Subject: Low-Emission Vehicle Regulatory Review Hearing

Re: Low Emission Vehicle Regulatory Review Hearing

RAF Concept is Fundamentally Flawed

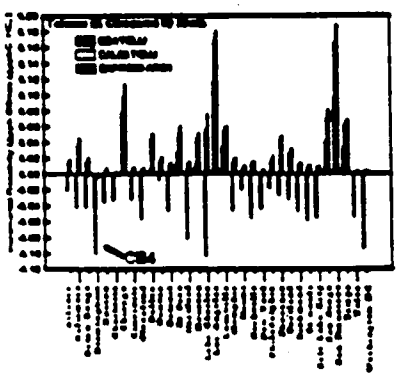
- ARB Tech Support Doc says, "The principle behind RAF concept is that equal impacts on air quality will result from reactivity-adjusted emissions that just meet the standard."
- It also says, "...it is not possible to derive a single RAF that yields equal air quality impacts in all places at all times."

No single RAF value for any urban area.

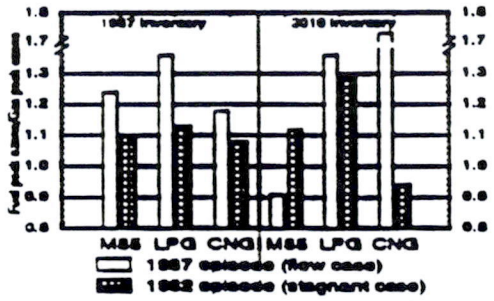
- Reactivities are a function of environmental conditions
- Environmental conditions vary across air shed and city-to-city
- Even Carter says, "scales are environmentally dependent"
- There can not be adjustments that result in equal impacts from different mass emissions.
